**SAFE
CLEAN
WATER
PROGRAM**

**Stormwater
Investment Plan
South Santa
Monica Bay
Watershed Area**

Fiscal Year 2025-2026

ATTACHMENT A: Project Modification Request (PMR) Form

Figure 1 – Original Concept Design Layout

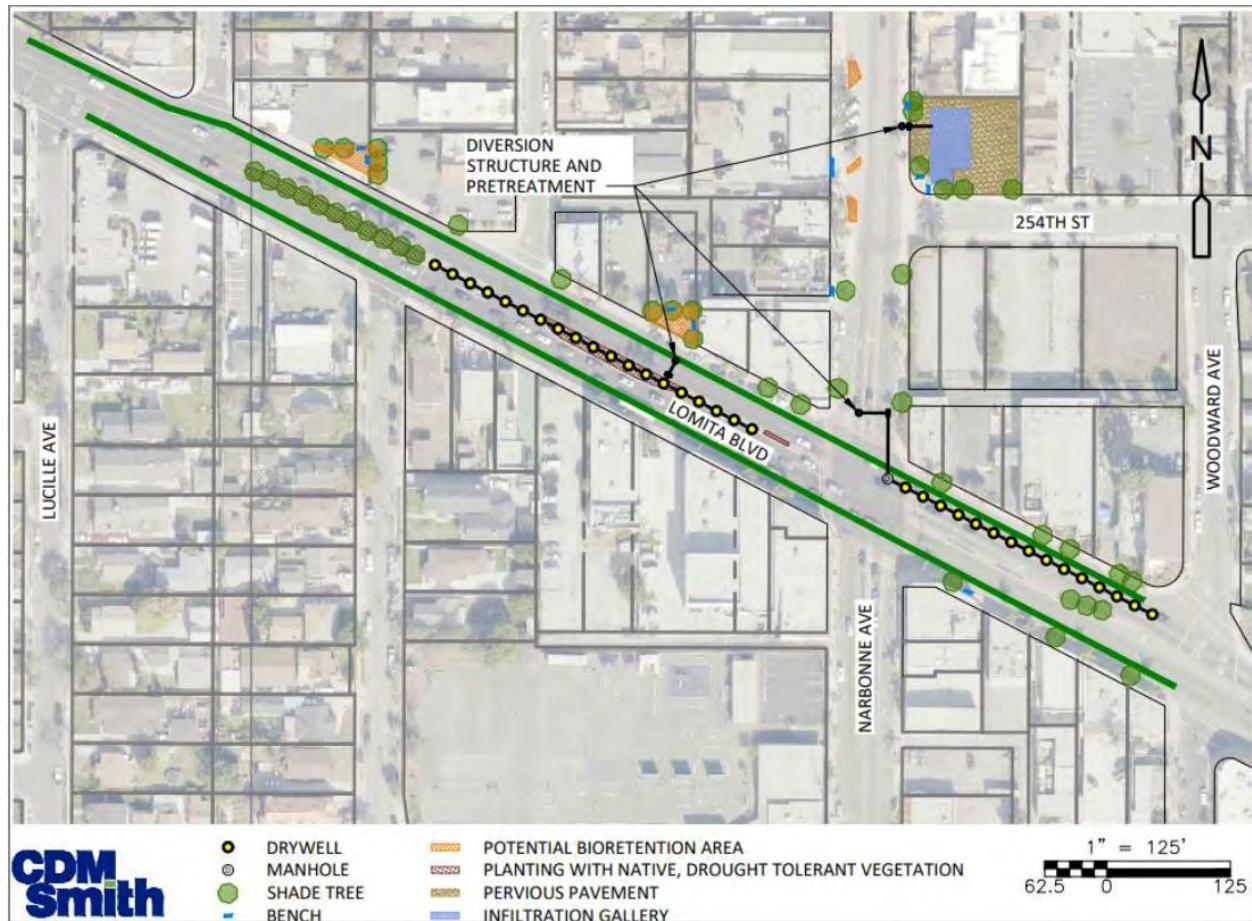
As shown in Figure 1, the original concept design begins on Narbonne Avenue and extends 450-feet south to Lomita Boulevard. It continues along the 1,100-foot length of Lomita Boulevard from Lucille Avenue to Woodward Avenue. The Project was intended to capture and infiltrate stormwater flow by infiltrating stormwater under a City-owned parking lot on Narbonne Avenue and in drywells under Lomita Boulevard. Other key components of the Project include the planting of 45 trees along Narbonne Avenue and Lomita Boulevard, new vegetated areas along the sidewalk and in the medians that will further capture stormwater in a natural way, and bioretention along Narbonne Avenue. Community aspects of the original design included benches, and the addition of a bike lane along Lomita Boulevard from Woodward Avenue to Lucille Avenue. Additional bike locking locations would also be provided in key locations to further encourage this healthy mode of transportation.

In October of 2020, geotechnical investigations were conducted at 2154 245th Street, directly adjacent to the proposed infiltration gallery location at the City-owned parking lot at 24418 Narbonne Avenue. Based on this investigation, an infiltration rate of 16.9 inches per hour (in/hr) was used to provide preliminary sizing for the infiltration best management practices (BMPs). The Project planned to capture and infiltrate 5.6 acre-feet (ac-ft) of stormwater over a 110-acre drainage area. 1.72 ac-ft would be captured by an infiltration gallery, 3.95 ac-ft by dry wells, and 0.03 ac-ft by surface BMPs. For further information regarding the original concept design, refer to the feasibility report included in Appendix A.

Figure 5 – Geotechnical Investigation Near Lomita City Hall

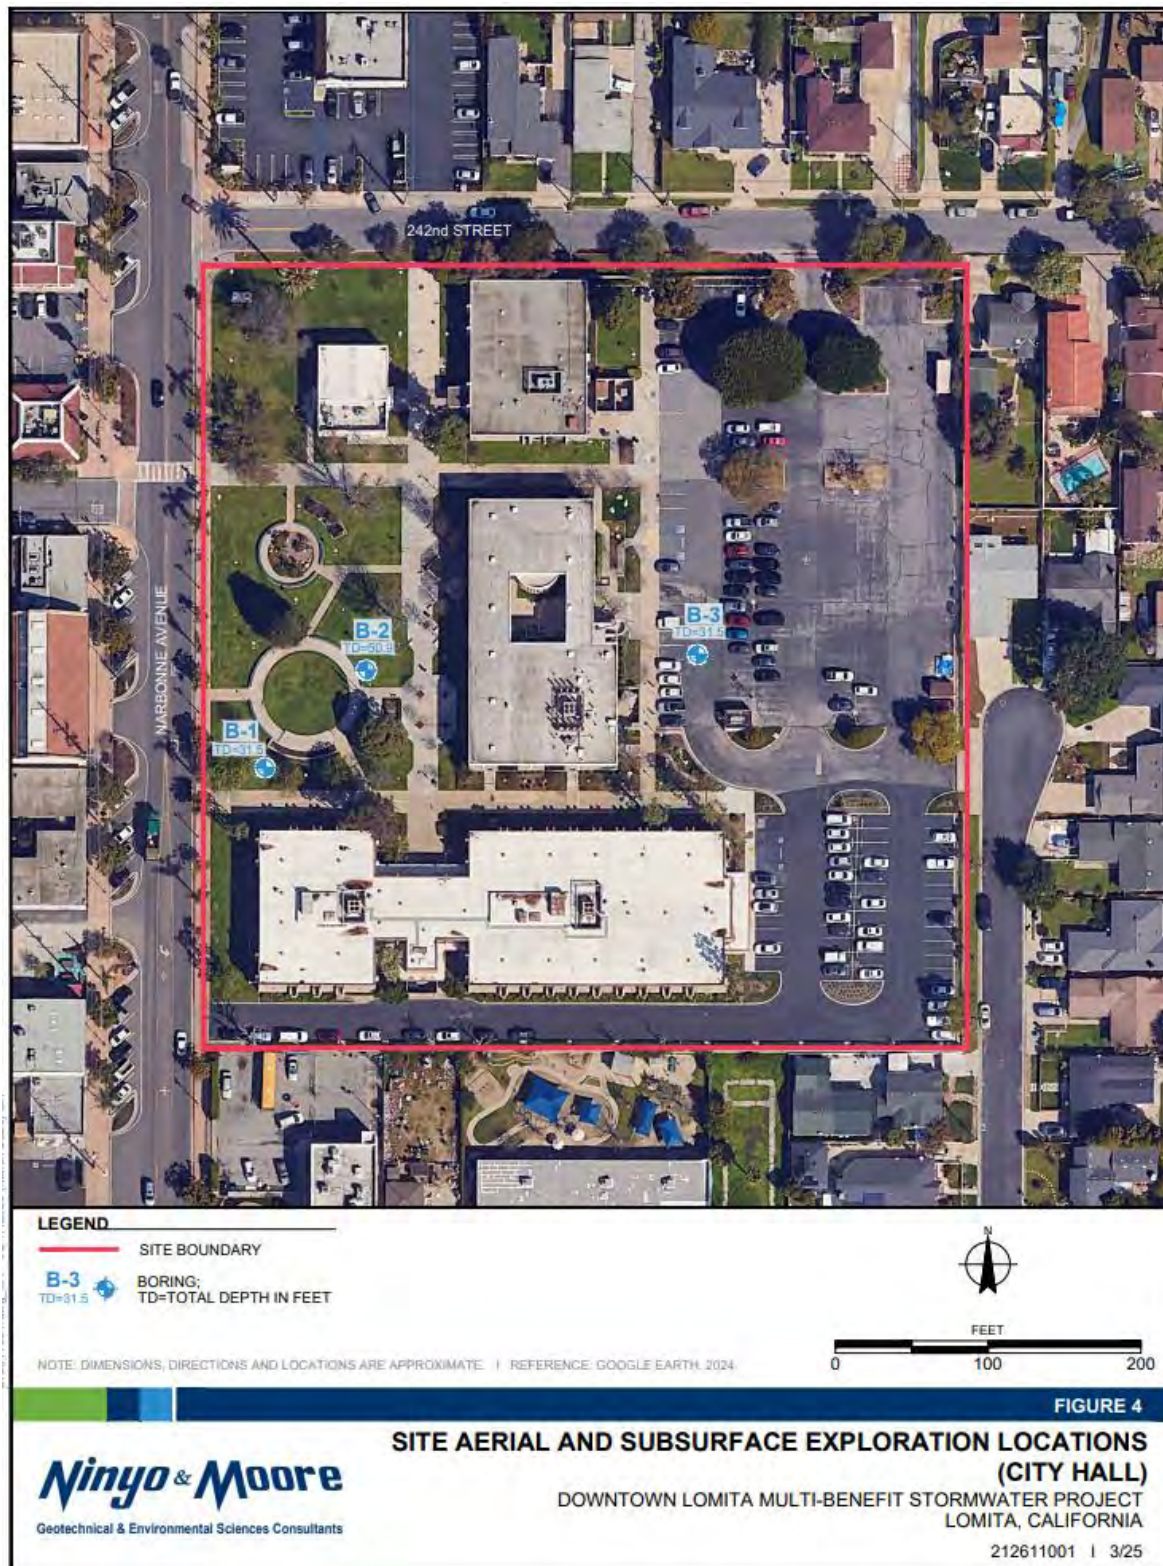
borings at two different depths at the City Hall locations. Figure 5 illustrates the precise locations and depths of these geotechnical testing sites.

Appendix C: Proposed Alternative Conceptual Design Drawings

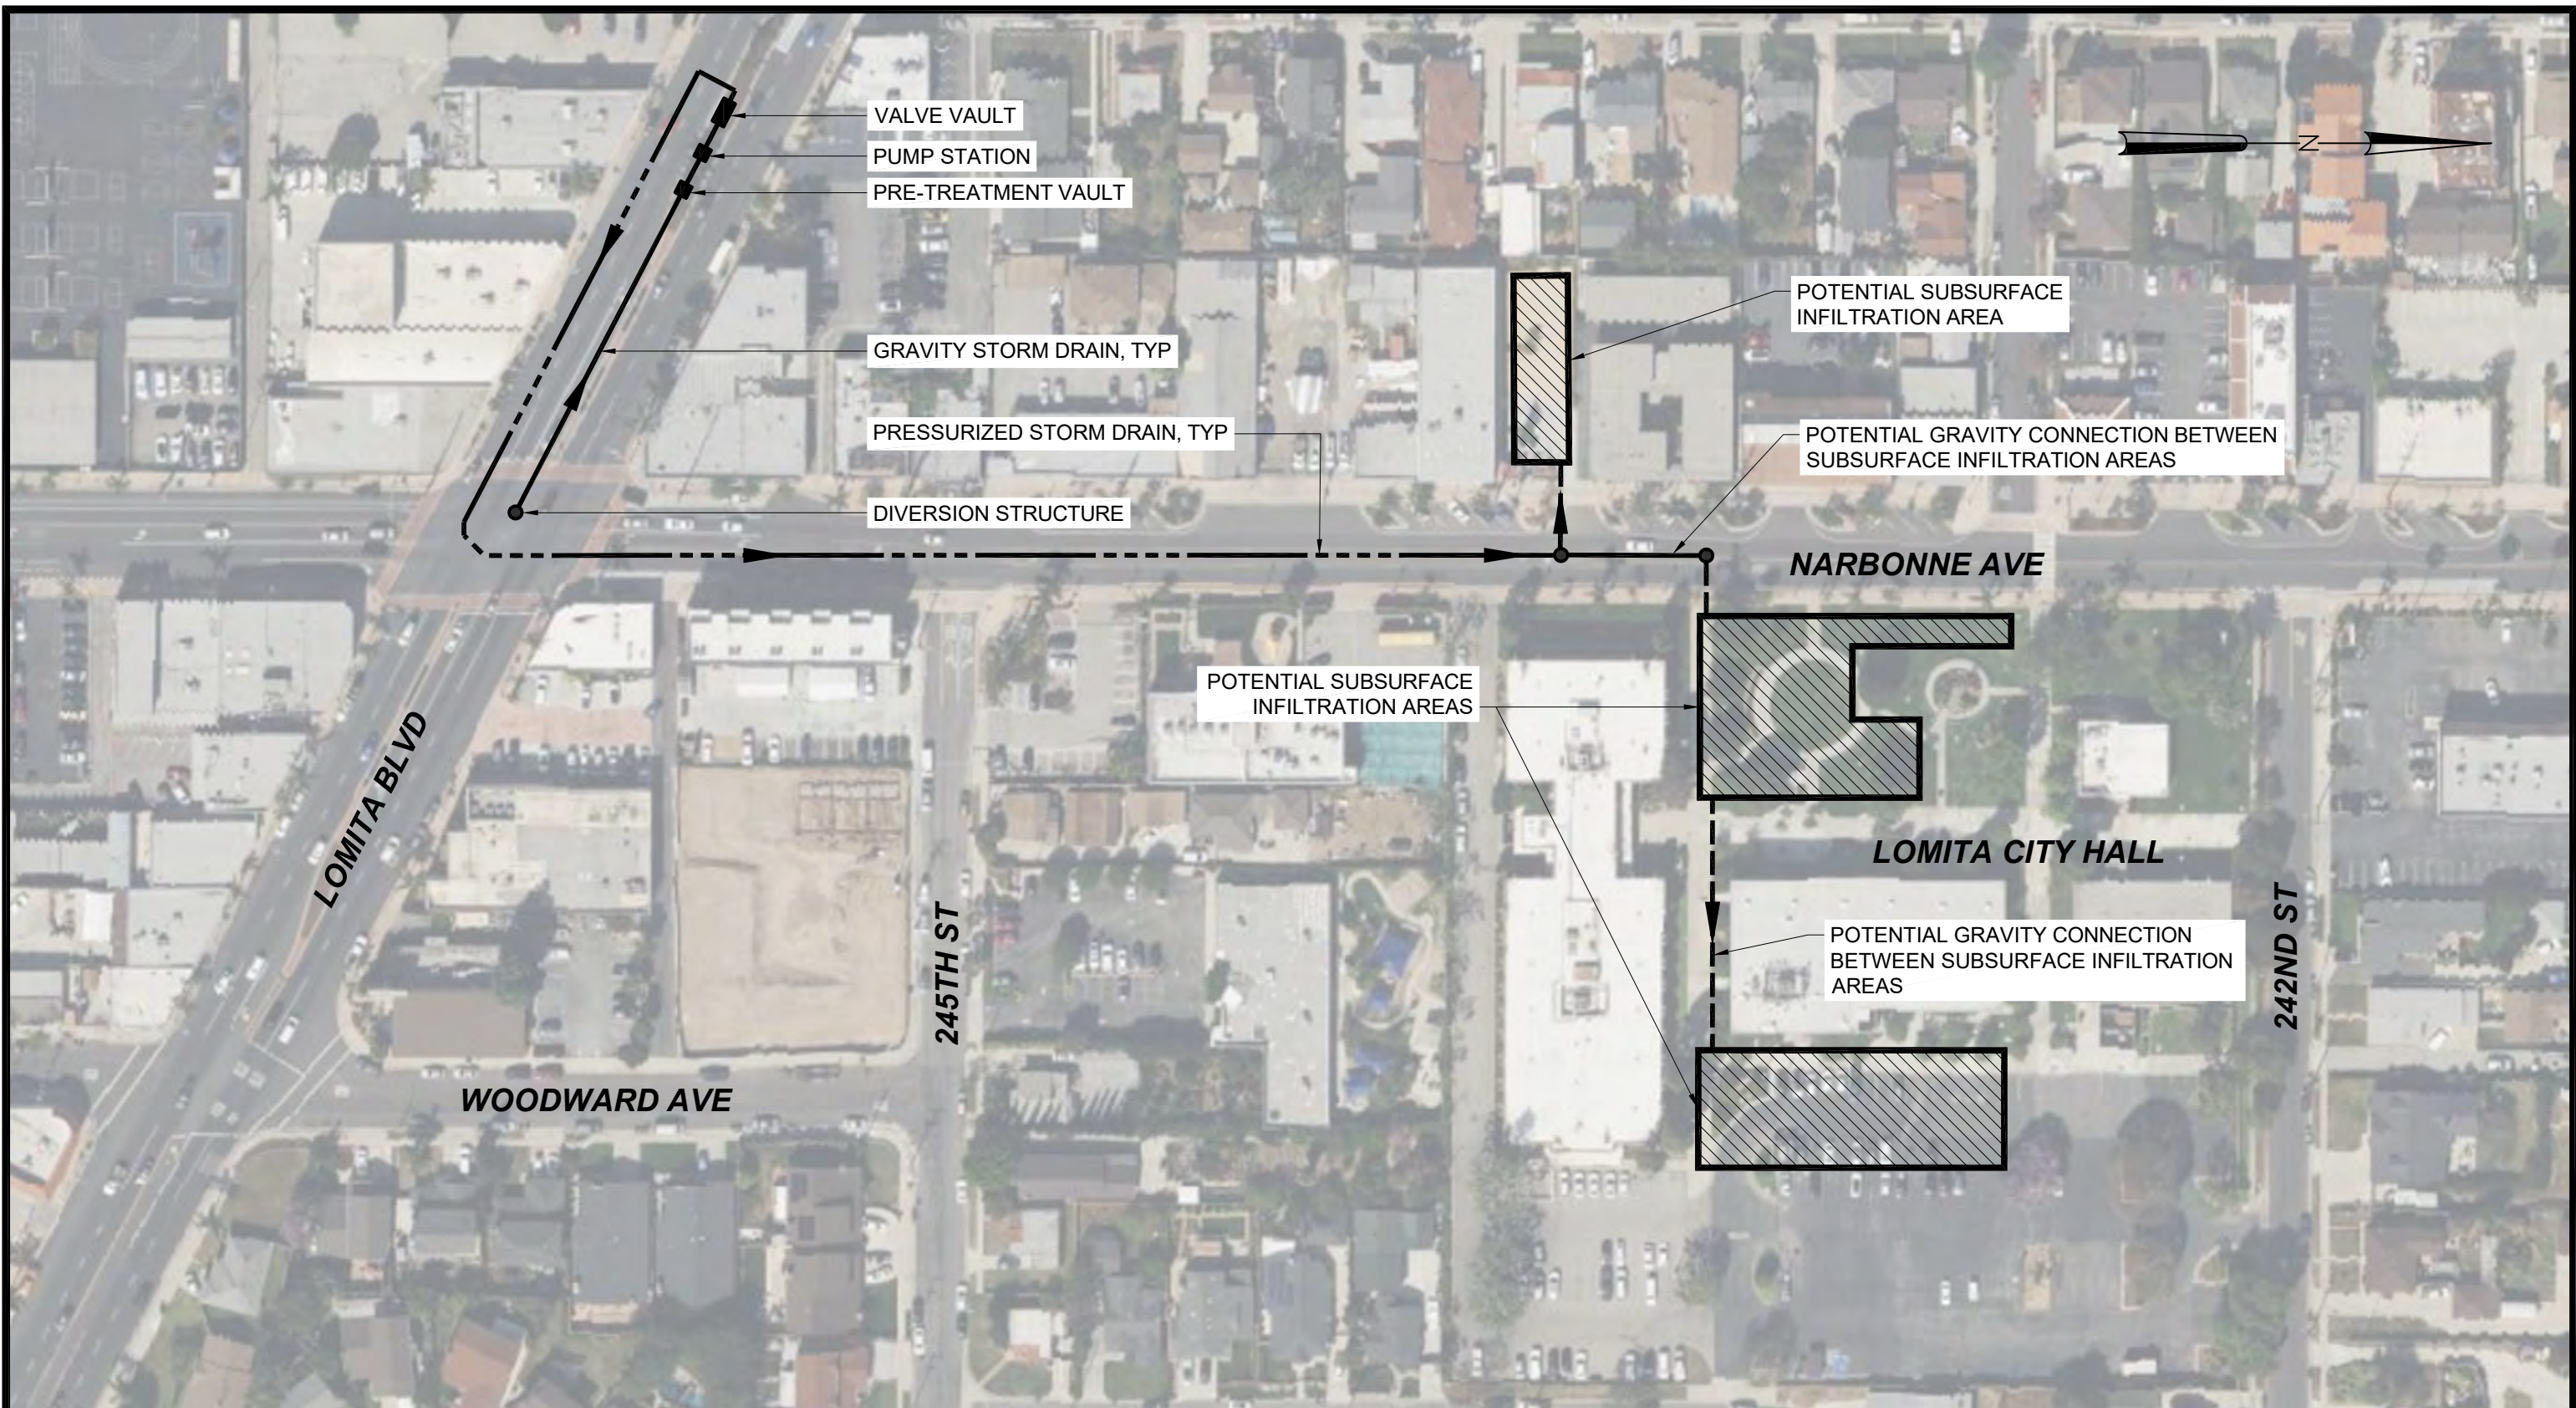
The City of Lomita's [Downtown Lomita Multi-Benefit Stormwater Project](#) PMR was deemed inconsistent due to a change in location and BMP type. The project originally selected a parking lot to install drywells but later discovered the site was unsuitable for infiltration. The new site at Lomita City Hall has lower infiltration rates so an infiltration gallery with a larger footprint is proposed to capture the full 85th percentile, 24-hour storm. This new site diverts stormwater downstream from the original location which allows for a change number of diversion structures from three to one.

A conceptual design for the proposed alternative is presented in Figure 5. This design includes a single diversion to capture the entire Project drainage area and incorporates a submersible pump station on Lomita Boulevard. Flow would be conveyed from the diversion to the proposed subsurface infiltration BMPs located at Narbonne Plaza and City Hall. The footprint required for an infiltration gallery installation is estimated at approximately 18,500 square feet with an internal gallery depth of 14 feet, including 1 foot of freeboard. It is anticipated that only the front of City Hall will be required but the back of City Hall provides additional space if needed. The Narbonne Plaza and City Hall subsurface infiltration BMPs are anticipated to be hydraulically connected.
